AMENDMENT OF SOLICITATION/MODIFICATION OF CONTRACT				1. CONTRACT ID CODE J		PAGE OF PAGES 1 2	
2. AMENDMENT/MODIFICATION NO. 0007		3. EFFECTIVE DATE 01-Sep-2016		4. REQUISITION/PURCHASE REQ. NO.		5. PROJECT NO. (If applicable)

14. DESCRIPTION OF AMENDMENT/MODIFICATION (Organized by UCF section headings, including solicitation/contract subject matter where feasible.) The purpose of this amendment is to make the following changes: 1. The award will be based on the basis of bids for the total amount of all CLINS. 2. To remove clause number 5252.215-9302. 3. To provide responses to enquiries. 4. Bids should be submitted in the following format - Price, 1 copy, single sided 8.5 x 11 inches per page; no technical proposals is required for this solicitation; with paper representations and certifications, 1 copy, single sided 8.5 x 11 inches per page. 5. Please submit bid bonds, 1 copy, single sided 8.5 x 11 inches per page. 6. Please page 2 through 6 for further changes and details, response to RFIs are highlighted.							
Except as provided herein, all terms and conditions of the document referenced in Item 9A or 10A, as heretofore changed, remains unchanged and in full force and effec

CURVE VANE GRATES WITH FRAME FOR DOUBLE TYPE "S" INLET (S2-CV)

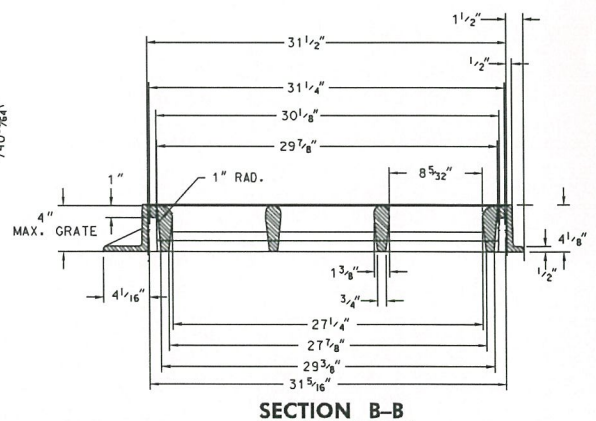
1.) Detail states that upon request a detail can be provided. Please provide detail.

Please see detail as an attachment to with Amendment # 7
